## HISTORIC AND DESIGN REVIEW COMMISSION

April 15, 2015

### Agenda Item No: 31

**HDRC CASE NO:** 2015-131  
**ADDRESS:** 720 N ST MARYS  
**LEGAL DESCRIPTION:** NCB 180 BLK LOT W IRRG 113.2 FT OF 18 ARB 20B  
**ZONING:** D RIO-3  
**CITY COUNCIL DIST.:** 1  
**APPLICANT:** Luna Architecture + Design  
**OWNER:** Dr. Felipe & Gloria Morales  
**TYPE OF WORK:** Exterior modifications  
**REQUEST:**

STREET VIEW

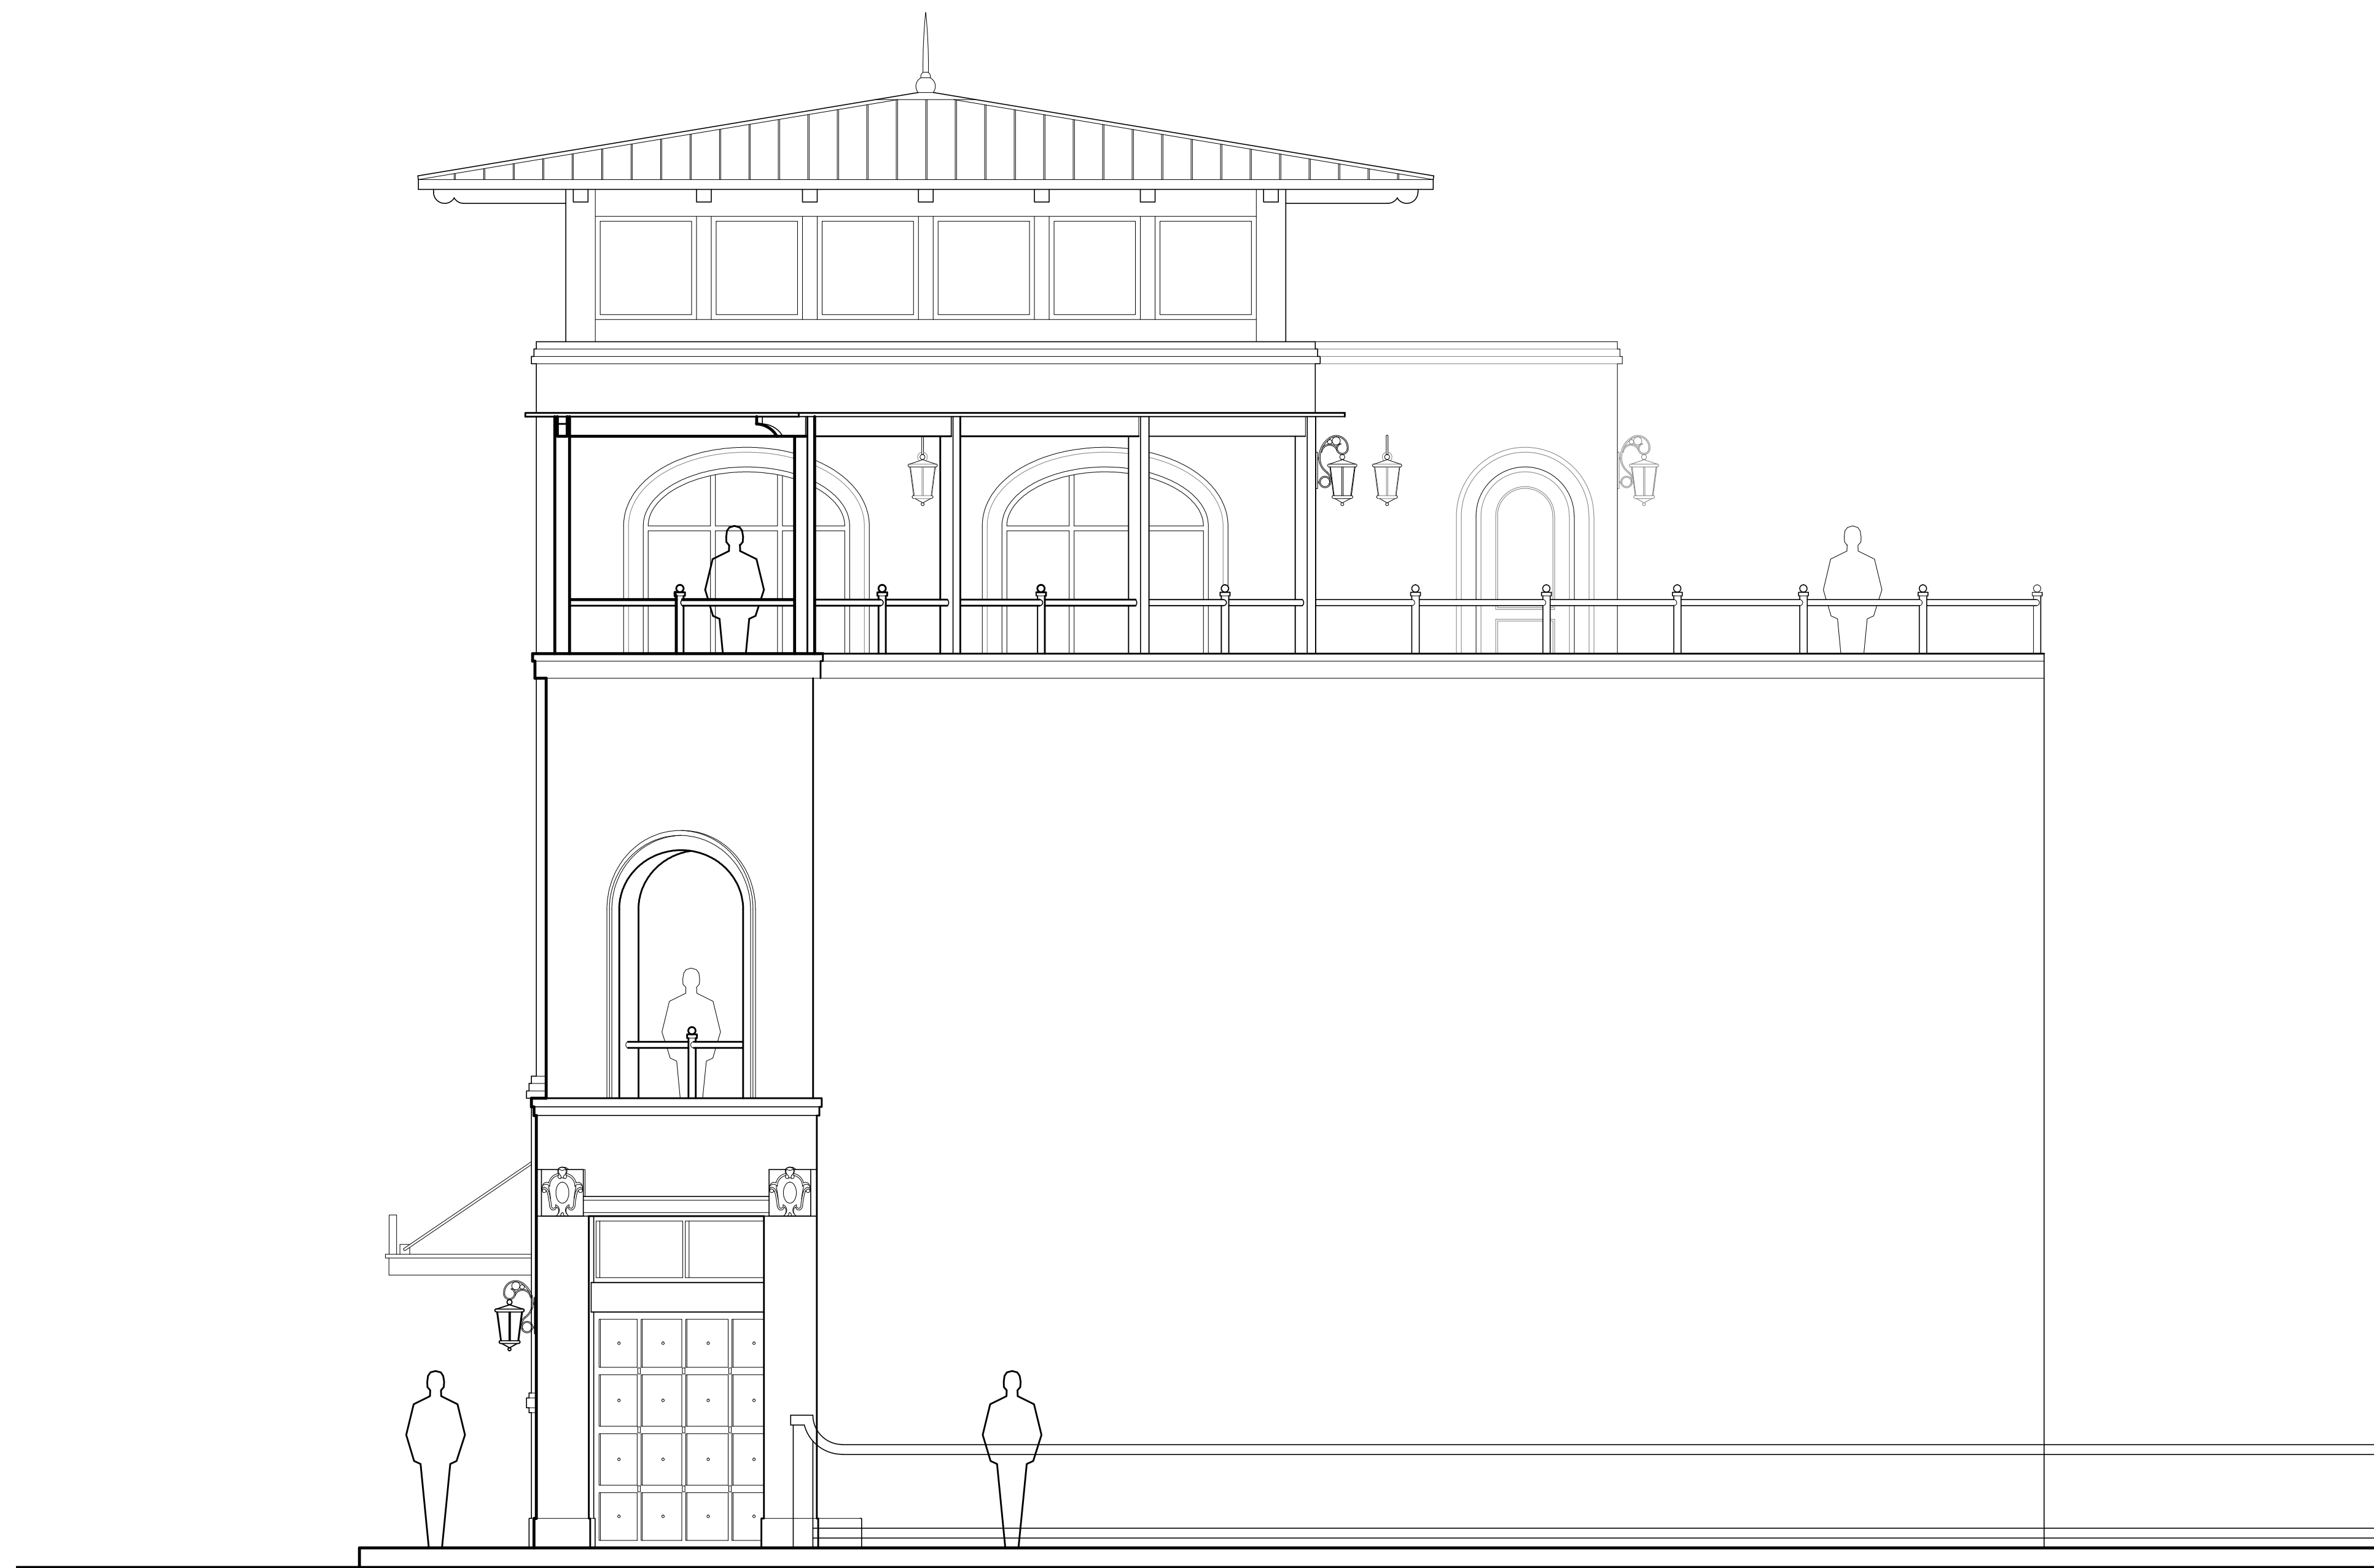
- a. The structure at 720 N St Mary's is a non-contributing structure built circa 1940. Currently, the property is zoned Downtown and RIO-3.
- b. The applicant has proposed to modify the existing façade arrangement of the structure by applying new, earth toned stucco with new window trim and window trim detailing. The UDC Section 35-674(d) states that indigenous materials such as stucco and other materials that convey the texture, scale and finish of traditional building materials should be used. The applicant's proposal to resurface the structure with stucco is consistent with the UDC. In addition to this, the emphasis on newly placed trim and molding helps to convey a human scale to the second and proposed third floor.

- h. The applicant has proposed to create new stucco arches throughout the project including locations on both the N St Mary's facades, the river façade and the open air court façade that forms where the river and N St Mary's meet. Given original massing of the structure staff finds that the arched entrances and window openings present a false sense of scale and do not coincide with the square window openings and other architectural features that complement them. Staff recommends that the applicant redesign the arched openings to become more consistent with the other openings throughout the project.

- i. That the applicant simplify the proposed railing to exclude the curved ornate design, utilize simple, square punched openings, eliminate the proposed arched openings and provide information regarding a final lighting scheme prior to receiving a Certificate of Appropriateness.

Staff does not recommend approval of items #8 and #9 based on findings h and i.
